SUBJECT: Forwards Draft responses to NRC Questions 231.1 to 231.5 per
 810803 request for addl info. Three oversize drawings encl
 Aperture cards will be available in PDR.

Subject: Palo Verde Nuclear Generating Station
(PVNGS) Units 1, 2 and 3
Docket Nos. STN-50-528/529/530
File: 81-056-026, G.1.10

Reference: Letter from R. L. Tedesco, NRC, to E. E. Van Brunt, Jr.,
dated August 3, 1981, Subject: Request for Additional
Information (Geology)

Figure 2-5-11

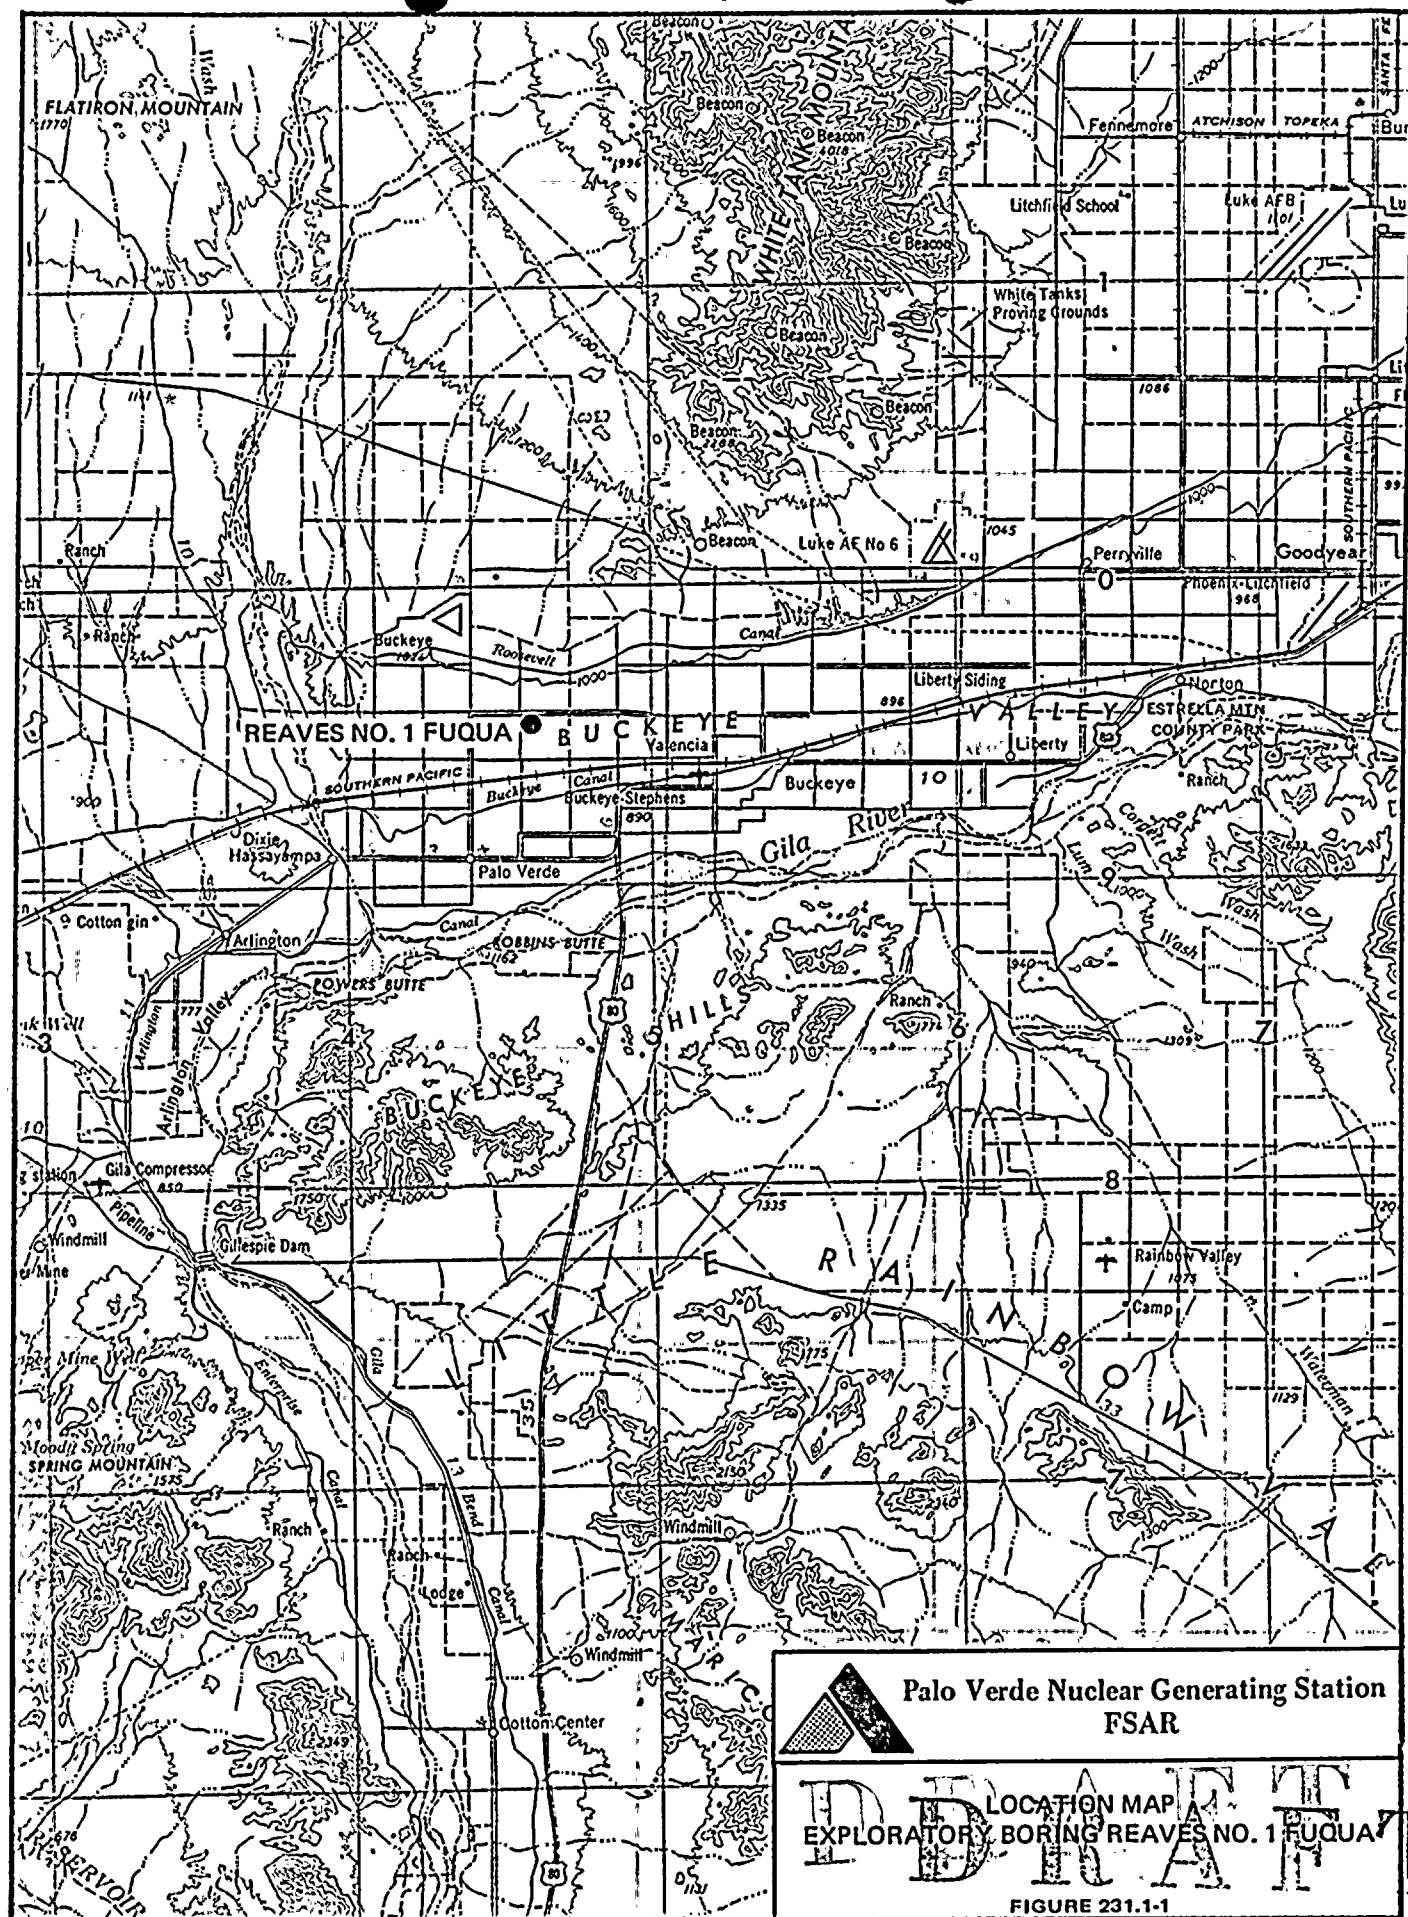
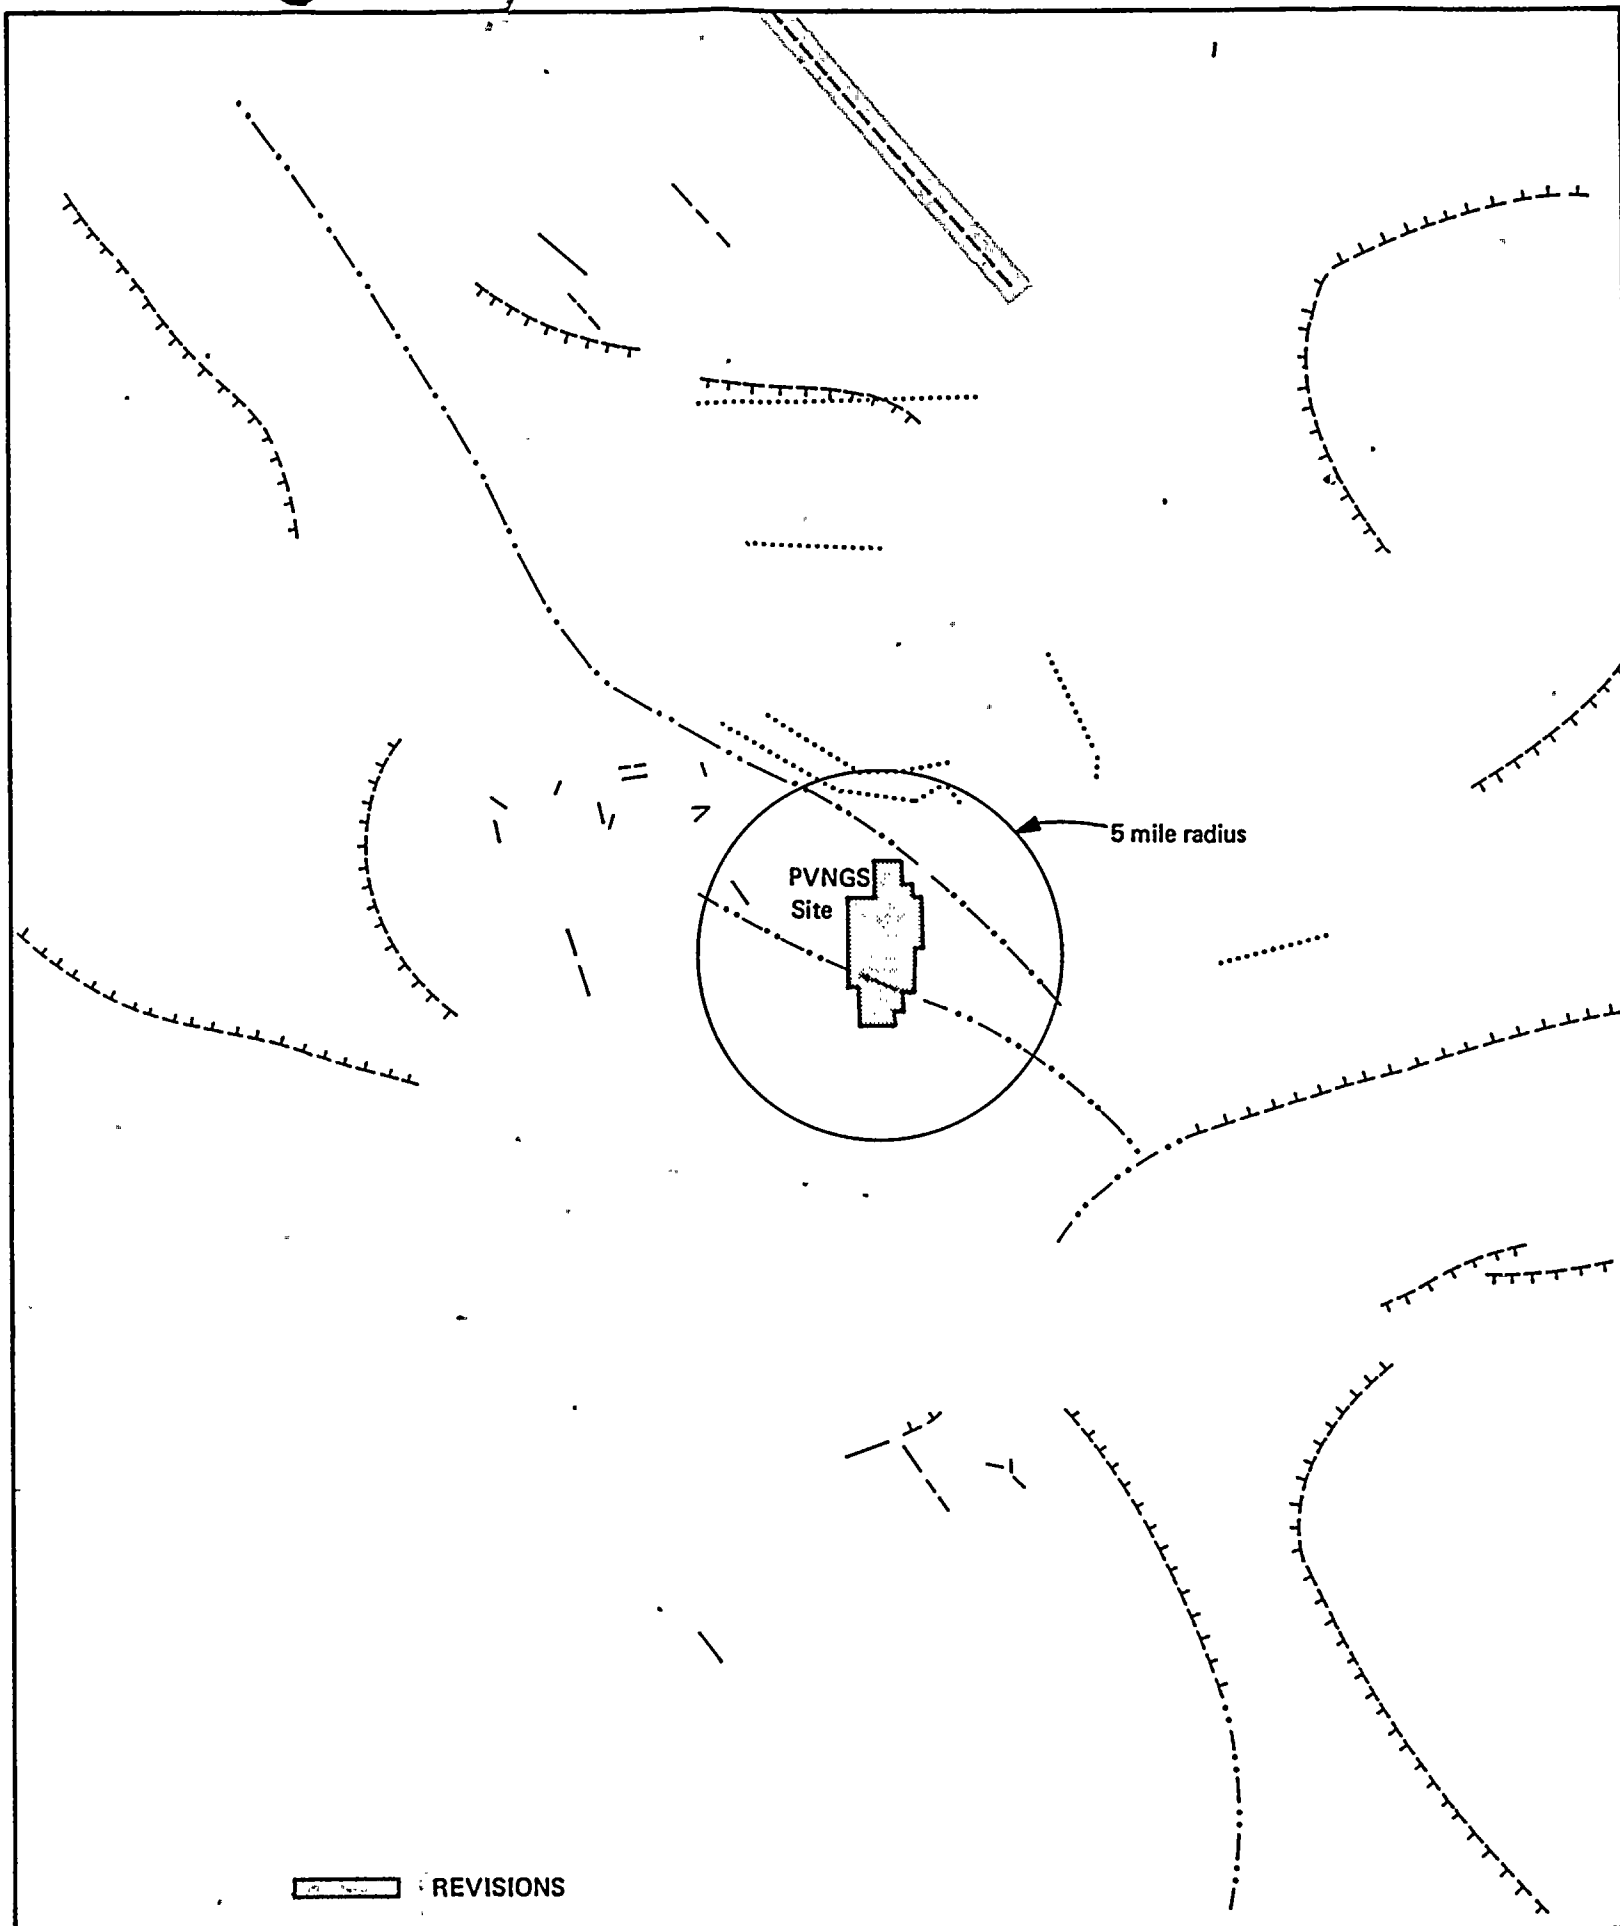
Figure 2 (page 6) of a November, 1979, Department of Energy Report shows two inferred faults in the Hassayampa Plain northeast of the Palo Verde Site. Discuss the validity of these faults and their site-safety significance. The DOE report is titled "Geothermal Studies in Arizona with Two Area Assessments (DOE/ID/12009-T4)."

Detailed geophysical surveys (gravity and magnetic) recently conducted by C. Cloran (Geophysics, Hydrology and Geothermal Potential of the Tonopah Basin, Maricopa County, Arizona, MS Thesis, Arizona State University, May, 1977) within five miles of the Palo Verde site indicate that the Tonopah Basin is bounded by normal faults. Discuss the impact of Cloran's interpretation of the subsurface with respect to:

- a. Site Safety
- b. The capability (or non-capability) of the basin-bounding faults suggested by Cloran.
- c. The validity of the structural interpretation of the Tonopah Desert area as shown on FSAR Figure 2.5-8 and other related FSAR figures.

FSAR Figure 2.5-8 shows a northeast trending hypothetical fault along the north boundary of the Belmont Mountains. However, it is located about two miles west of the northwest trending fault on Figure 2 of the referenced article. The fault in FSAR Figure 2.5-8 was taken from a small scale tectonic map of North America which placed faults along margins of most major mountain ranges. The

accuracy of location of those hypothetical faults is unknown and the geologic reasoning for their location is not described. Therefore, the fault on the FSAR Figure 2.5-8 represents essentially the same range bounding structure in Figure 2 expect that locations of the two faults vary slightly due to map scale and minor interpretive differences. FSAR Figure 2.5-8 has been revised to reflect the results of these latest studies.

The structural interpretation shown on Figure 2.5-8 and 2.5-9 is still valid in terms of the basic basin geometry and the significant structural features of safety significance to the site. There will be the addition of some details from Cloran's work to make the data base more complete.

Figure 2.5-6

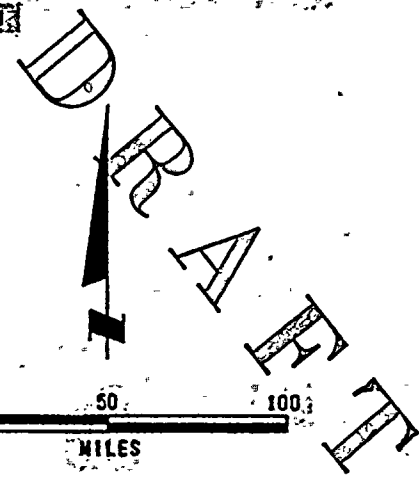
Describe the basis used for categorizing the fault (see FSAR Figure 2.5-6) in the Sand Tank Mountains area some 35 miles SE of the Palo Verde site as older than 500,000 years.

The weight of line used to depict the age of the fault near the Sand Tank Mountains is a drafting error. In the absence of any detailed geologic investigations, we consider the Sand Tank fault as younger than 500,000 years and the FSAR Figure 2.5-6 will be modified accordingly.
